CWSP SYSTEM HARDENING FIELD SCOPING DOCUMENT

PM: [REDACTED]	Project Name: ECOP - SILVERADO 2102 - H02-LR58626	
Notification: [REDACTED]	Region: Bay Area	City: Saint Helena
Project Manager: [REDACTED]	Division: North Bay	County: Napa

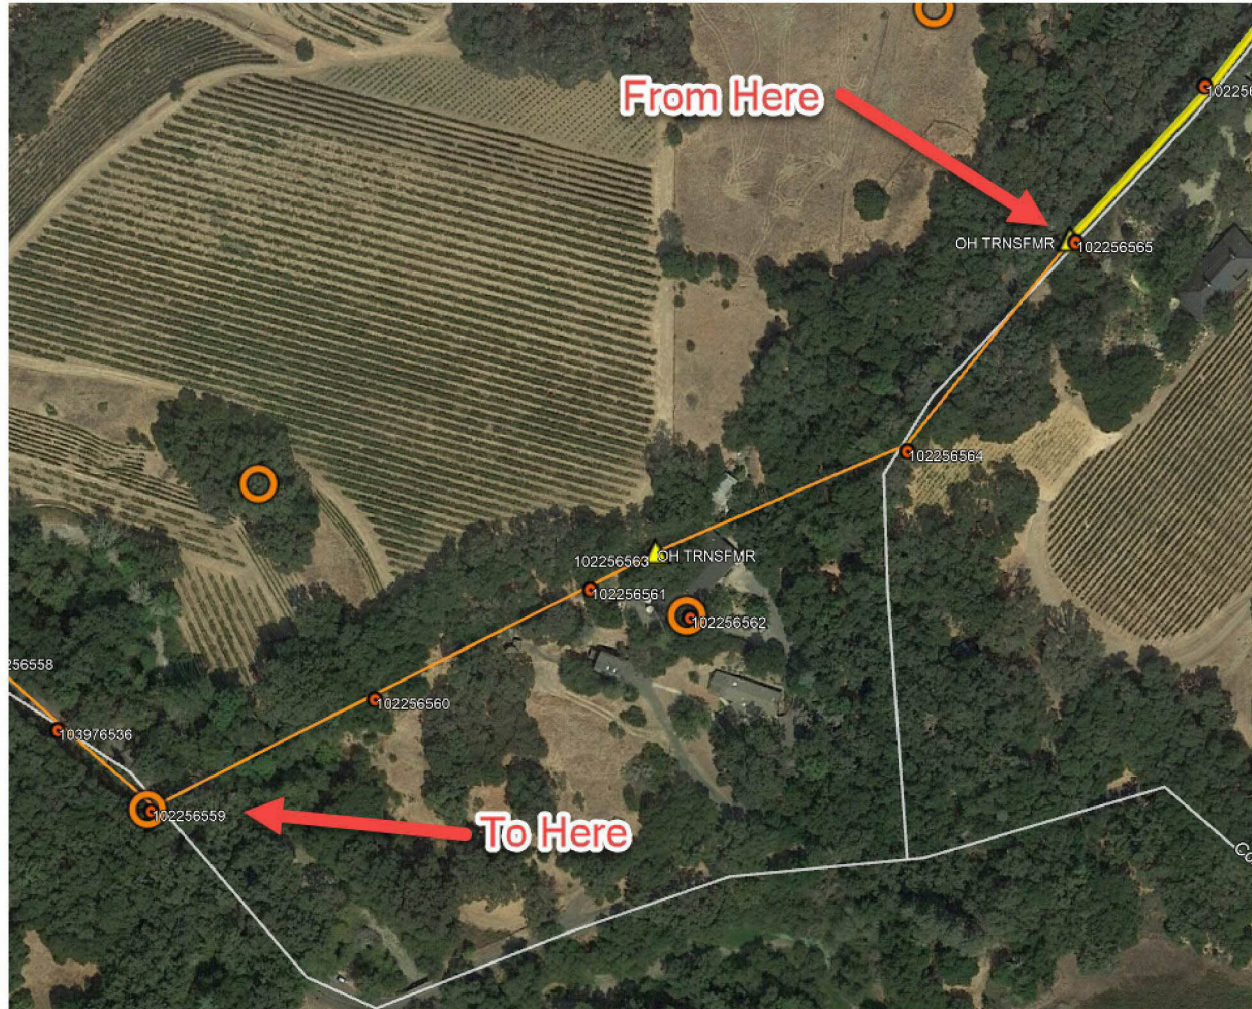
An ideal underground conversion not identified for this project. There are currently 6 existing poles within this project's footprint located on the road (+/- 1,000' of conductor). Poor road condition – 1.5 lanes narrow road & not enough space for subsurface or pad-mounted equipment.

Scope expansion recommendation – add 5 spans to the southwest:

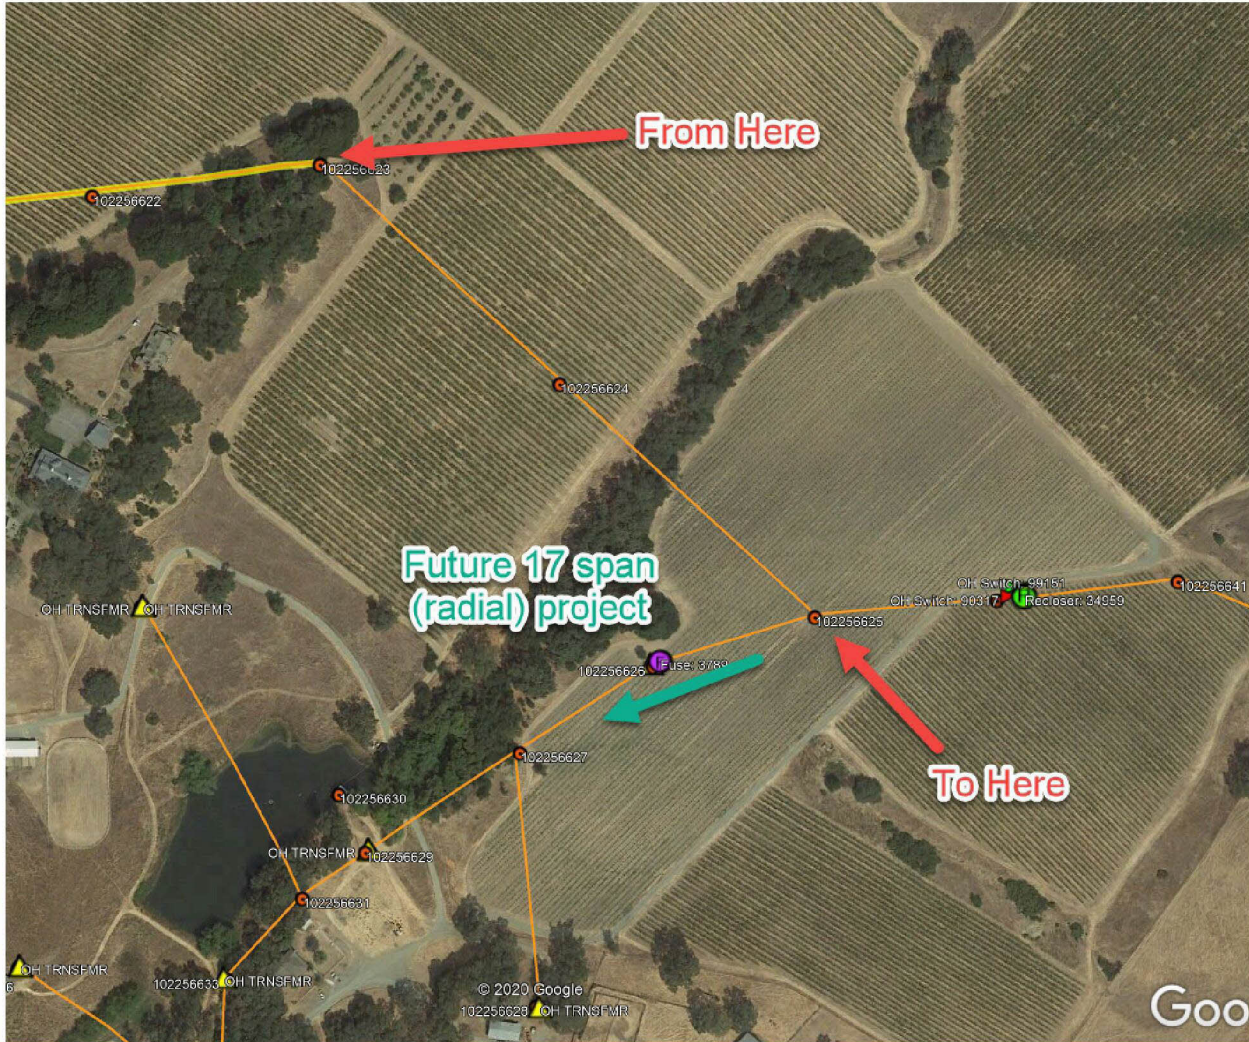
From SAP ID [REDACTED] to SAP ID [REDACTED]

SAP [REDACTED] is a corner pole, which allows for an easy transition to the new conductor. There is an existing anchor & there is plenty of existing space for new anchor/guying.

These added spans will eliminate two spans of open wire secondary & clear three additional 07D jobs (Notif: [REDACTED])
